2CAN080306

SUBJECT: Arkansas Nuclear One, Unit 2
Docket No. 50-368
License No. NPF-6
Supplemental Response to the Bare Metal Visual Relaxation Request for
ANO-2 Regarding NRC Order EA-03-009

**Supplemental Response to the Bare Metal Visual Relaxation Request for ANO-2
Regarding NRC Order EA-03-009**

Figure 1

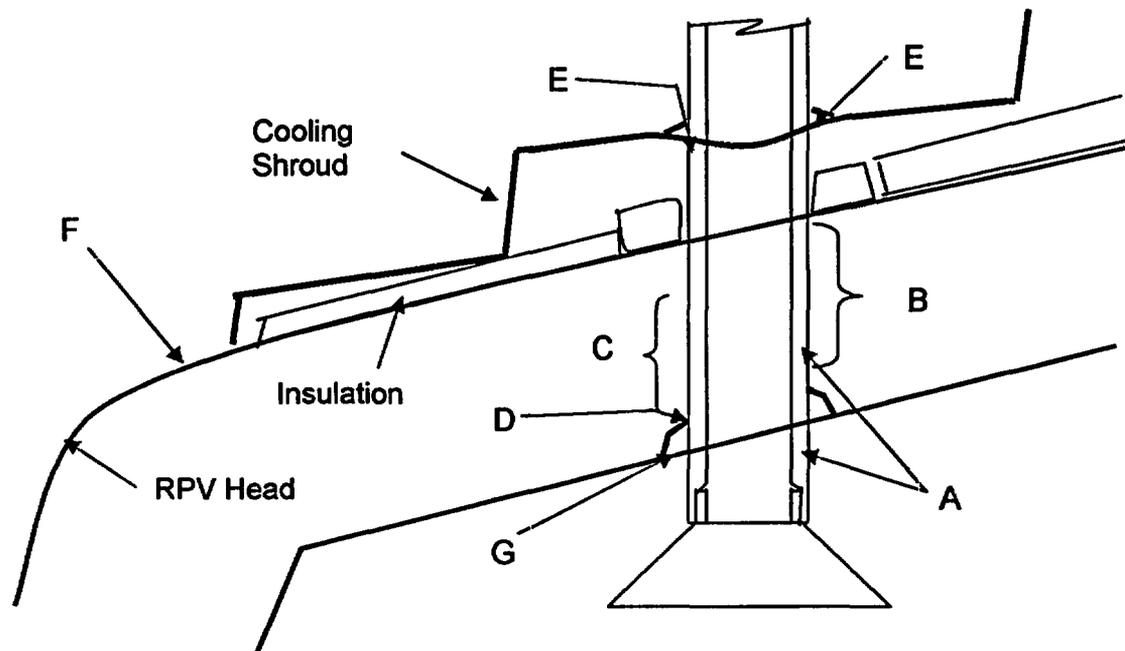
Pertaining to the overall approach address how an acceptable level of quality and safety is met, if the proposed approach represents a reduction from the level that would be provided by BMV (why is this okay?).

The overall approach for ensuring that an acceptable level of quality and safety is being met is provided by the comprehensive examinations of the ANO-2 RPV head in the fall 2003 refueling outage as discussed below. The basis for this conclusion is provided in the subsequent portion of this response by showing compliance to the Order and not having a significant reduction in the level of quality and safety from the proposed inspection regime.

Comprehensive Approach to ANO-2 Reactor Head Inspection - The unique "stair-step" shroud configuration at ANO-2, as discussed in Reference 2, creates a hardship in performing the BMV examination to meet the requirements of NRC Order EA-03-009. Because of this hardship, Entergy has worked closely with Westinghouse to develop new examination approaches, as well as improvements to some of the traditional inspection techniques in order to provide an overall RPV head inspection approach that provides an acceptable level of quality and safety. The ANO-2 reactor head inspection approach that is being applied in lieu of a BMV inspection for the fall 2003 refueling outage is a comprehensive methodology. This inspection regimen is designed to provide defense in depth for detection capability of any PWSCC flaw that could develop in the J-groove weld or penetration nozzle. This comprehensive approach combines the use of several diverse and complementary inspection techniques. These techniques culminate to provide a complete examination and inspection of the RPV head which provides an appropriate level of quality and safety. This complementary inspection approach is best illustrated by the following sketch (Figure 1) which demonstrates how each examination and inspection technique covers the entire length of the penetration to ensure that PWSCC indications are found in the nozzle or J-groove weld, penetration leakage is detected, and that the RPV head integrity is maintained.

Primary Examinations

- A = Volumetric Examination of CEDM/ICI penetration tubes utilizing MRP demonstrated UT techniques.** This ensures that the critical length of the nozzle is free of defects and potential leakage paths.

- B = Low Frequency Eddy Current Examination of the portion of the CEDM and vent line penetrations that are above the J-groove weld.** This examination will interrogate the area between the penetration tube and the reactor head looking for degradation of the carbon steel head material.

- C = Penetration Annulus Leakage Assessment using Westinghouse demonstrated zero degree UT technique.** This ensures that the leak path from a leaking nozzle or weld will be detected and qualitatively determined to have a loss of interference fit through the annulus which can also be detected by LF ECT. This examination can detect leakage through the J-groove weld or through the buttering, if it were to occur.

- D = Triple-Point Examination utilizing Entergy/Westinghouse developed and EPRI/MRP demonstrated UT technique.** This process provides the unique capability to further investigate 0.060" into the J-groove weld and determine the integrity of the penetration weld and to support the conclusion that boric acid deposits will not be present on the RPV head.

- E = Supplemental Visual Inspection performed from above the cooling shroud plate,** which has the capability of detecting boric acid that has either descended onto the head from

F = Bare Metal Visual Inspection of the accessible portions of the RPV head, including the flange area, part of the lower dome, and around the annulus of the ICI nozzles. This examination is performed to detect corrosion that may have occurred in the accessible areas, to detect leakage around the ICI nozzles, and to look for evidence of boric acid residue that may have run down the head from a leaking penetration.

G = Surface Examination of J-Groove Weld utilizing liquid penetrant or eddy current. This is a contingency examination that would be utilized to further investigate a positive indication of a potential PWSCC flaw found with any of the primary examination techniques.
